SERVICE BULLETIN

BULLETIN NUMBER: 10

MODEL: Westerbeke 40 and WPDS 10-15

SUBJECT: Sea Water Pump Clearance and Alignment

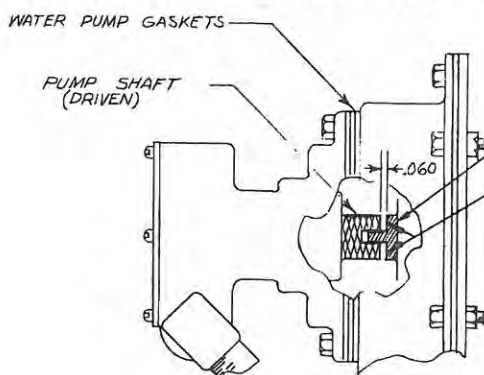
Adequate longitudinal clearance between the sea water pump shaft and the driving shaft is established by the use of multiple pump gaskets. The number of gaskets required can vary from 1 to 4. Enough gaskets must be used so that the shaft ends do not mate. See figure 1.

The application of liquid or paste type Prussian blue (at points indicated by arrows) will give positive indications of pump drive contact which will require the use of additional gaskets.

If the proper clearance is not maintained, the sea water pump shaft will force the fuel pump drive hub against its bushing. The bushing will seize to the drive hub and rotate in its housing. Bushing wear and loss of oil pressure will result.

When replacing the sea water pump be sure that the same number of gaskets is replaced and there is the required clearance.
